Re: Supplemental Comment on the Summit Avenue Warehouse Project (Master Case No. 21-040; General Plan Amendment No. 21-001; Zoning Change No. 21-002; Design Review No. 21-014; and Development Agreement No. 22-001) (City Council Agenda, Public Hearing Item A – Part No. 1)

I am writing on behalf of Supporters Alliance for Environmental Responsibility (“SAFER”) regarding the Initial Study and Mitigated Negative Declaration (“IS/MND”) prepared for the Summit Avenue Warehouse Project (“Project”) (Master Case No. 21-040; General Plan Amendment No. 21-001; Zoning Change No. 21-002; Design Review No. 21-014; and Development Agreement No. 22-001), for Applicant Ray Allard of Allard Engineering (“Applicant”), including all actions related or referring to the proposed construction and operation of an approximately 102,380 square foot industrial commerce building, located on the northeast corner of Sierra Avenue and Summit Avenue, in the City of Fontana, California (APN: 0239-161-28).

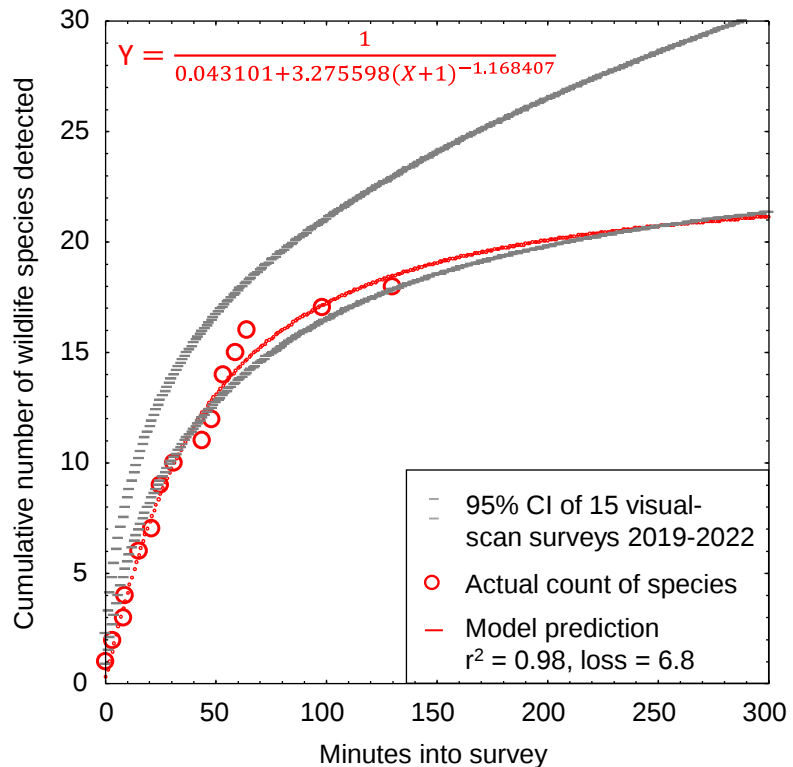
Figure 1 also reveals that the richness of the wildlife community at the project site is at within the 95% CI of mean species richness among the proposed project sites Noriko and I have surveyed in the region of the project site over the past three years. Relative to other proposed project sites in the region, the site of the proposed project supports lower species richness, but the model nevertheless predicts 23 species could have been detected that very morning of the 28th had more biologists been available. The site supports plenty of species of wildlife, and there can be no doubt that it provides ample habitat value to wildlife – more than this model can predict, because the model is based on one survey of one morning.

Figure 2. Mean (95% CI) predicted wildlife species richness, $\hat{R}$, as a nonlinear function of hour-long survey increments across 46 visual-scan survey stations across the Altamont Pass Wind Resource Area, Alameda and Contra Costa Counties, 2015–2019.

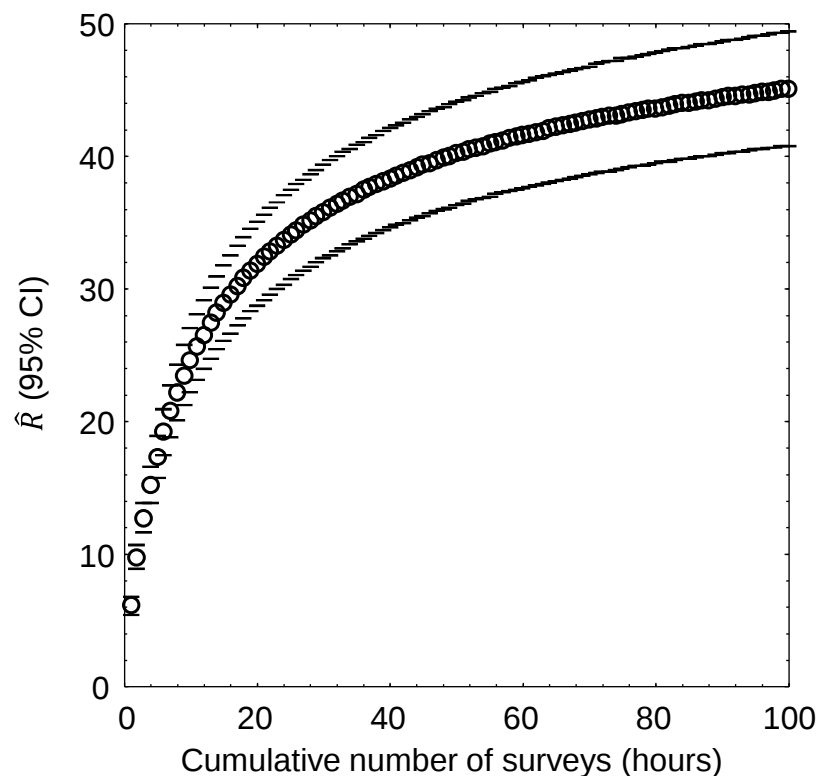
Again, however, my prediction of 89 species of vertebrate wildlife is derived from visual-scan surveys during the daytime, and would not detect nocturnal mammals. The true number of species composing the wildlife community of the site must be larger. A reconnaissance-level survey should serve only as a starting point toward characterization of a site's wildlife community, but it certainly cannot alone inform of the inventory of species that use the site. Without careful interpretation, UltraSystems' survey outcome should not represent baseline conditions, because there were truly many more species that used the site at the time of the survey than were detected by

UltraSystems. UltraSystems managed to detect but a very small fraction of the wildlife community that occurs at the site, having detected only 5 of ≥ 89 , or 5.6% of diurnally active species.

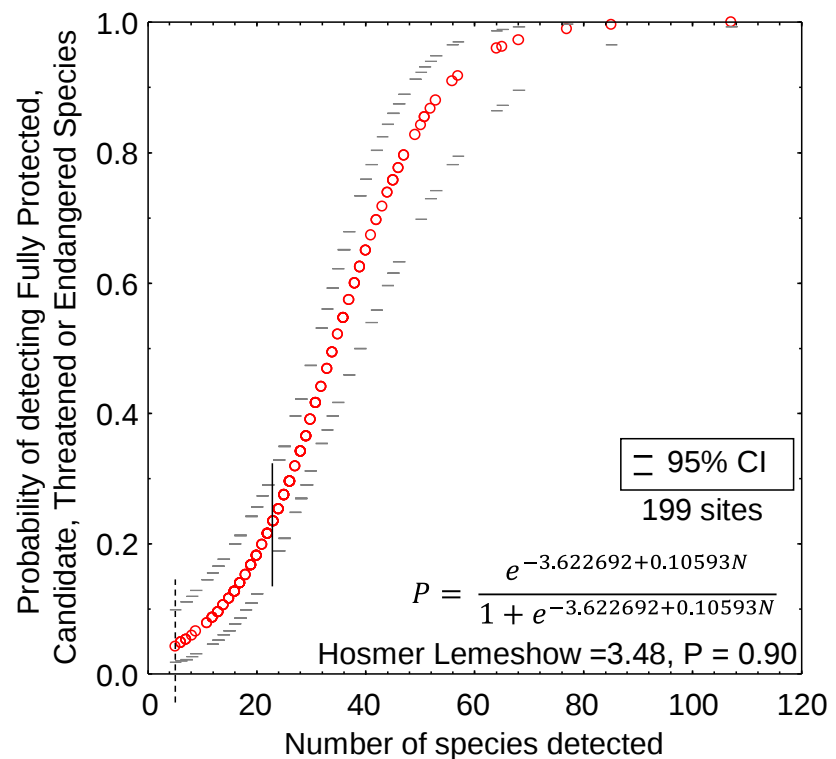
As demonstrated in Figures 1 and 2, the number of species detected is largely a function of survey effort. Greater survey effort also increases the likelihood that listed species will be detected (which is the first tenet of detection surveys for special-status species). Based on the outcomes of surveys earlier completed at 199 project sites, Noriko’s survey effort at the project site carried an 23% chance of detecting a listed species, whereas the survey effort of UltraSystems carried a 4% chance. Listed species of vertebrate wildlife likely use the site, but conclusively documenting their use would take more survey effort to achieve a reasonable likelihood of detection. No reconnaissance-level survey is capable of detecting enough of the wildlife species that occur at a site to realistically characterize the site’s wildlife community, including the site’s special-status species. A

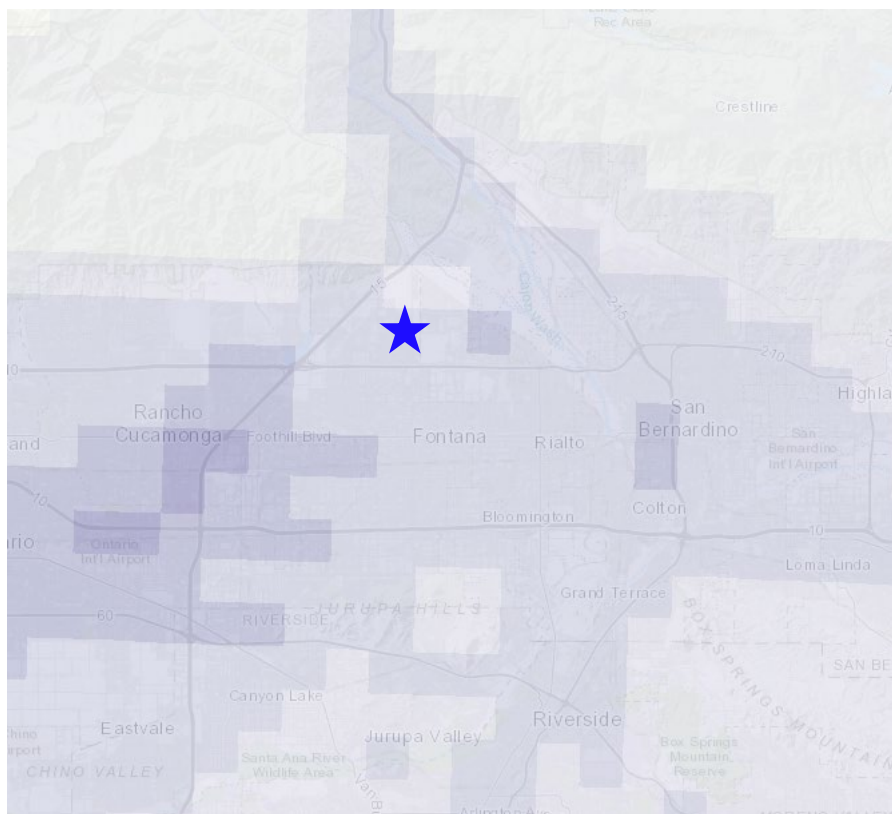
Furthermore, the Data Visualization Tool for Mates V, a monitoring and evaluation study conducted by SCAQMD, demonstrates that the City already exhibits a heightened residential carcinogenic risk from exposure to air toxics (see excerpt below).²⁹

Therefore, development of the proposed warehouse would disproportionately contribute to and exacerbate the health conditions of the residents in Fontana.

Kordyak Elementary School

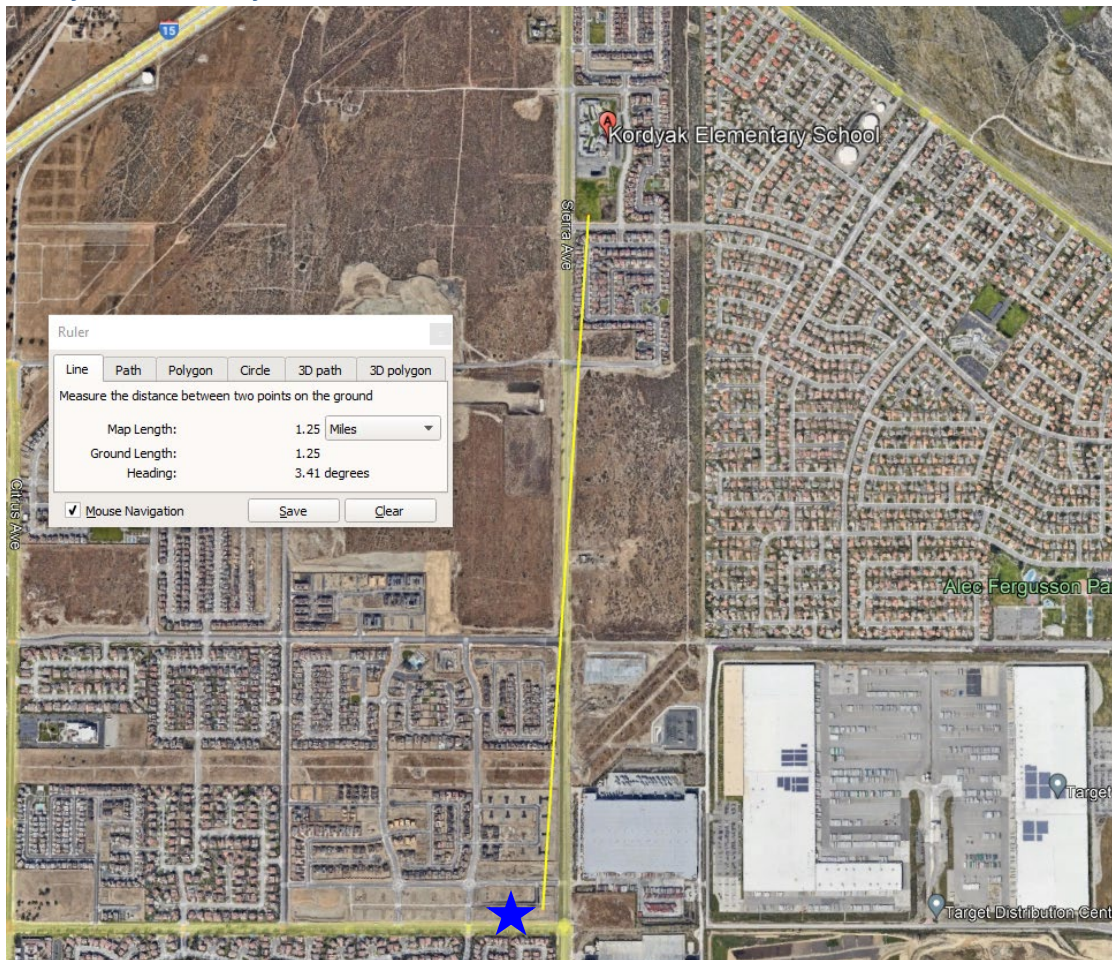
This poses a significant threat because, as outlined above, children are a vulnerable population that are more susceptible to the damaging side effects of air pollution. As such, the Project would have detrimental short-term and long-term health impacts on local residents and children if approved.
